CALL NO. 107
CONTRACT ID NO. 162206
ADDENDUM # 1

Subject: Laurel County, HSIP 9010 (251)
Letting August 26, 2016

KY 3094 HSIP Shoulder Widening

Pipe Section

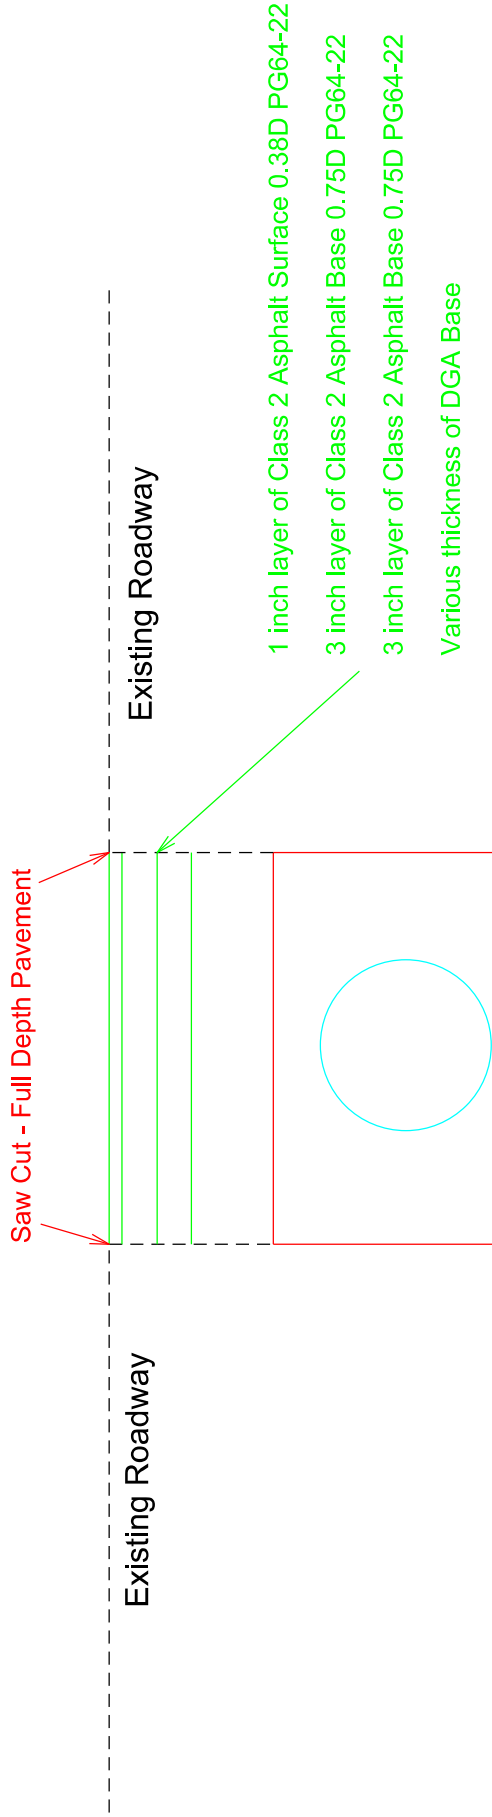
Geotextile Fabric Type IV shall be placed around the pipe bedding
DGA will be placed from the Geotextile Fabric to the top of the trench
and remain in place for a 2 week period to allow settlement. Once this time
frame has passed, the DGA will be removed below the surface of the road
a depth of 7 inches and the pavement structure shown will be placed.

**Saw Cut - Full Depth Pavement will be included in the price for
Pipe Removal and will done to ensure a Clean Pavement Edge**
